Disability Access Report

Seniors Living Development
2A Maude Street
BELMONT NSW 2280

For: Oak Tree Group
Ref: LP_21199

Figure 6 | Pedestrian Entry

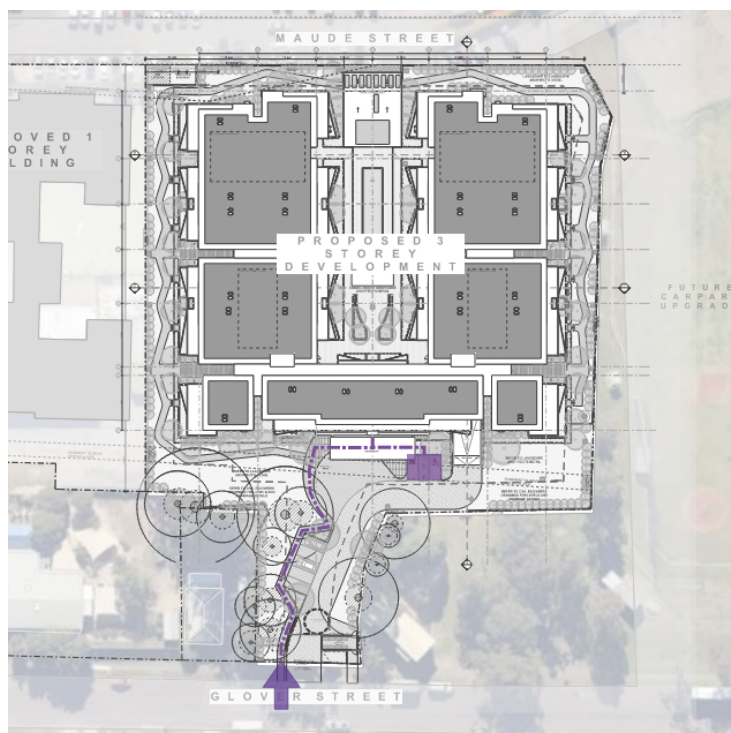
6.1 Approach from Allotment Boundary at Pedestrian Entry

The BCA requires that a continuous accessible path of travel be provided from the allotment boundary at the main points of pedestrian entry to the main entrance.

An accessible path of travel is provided from Glover Street to the main entrance.
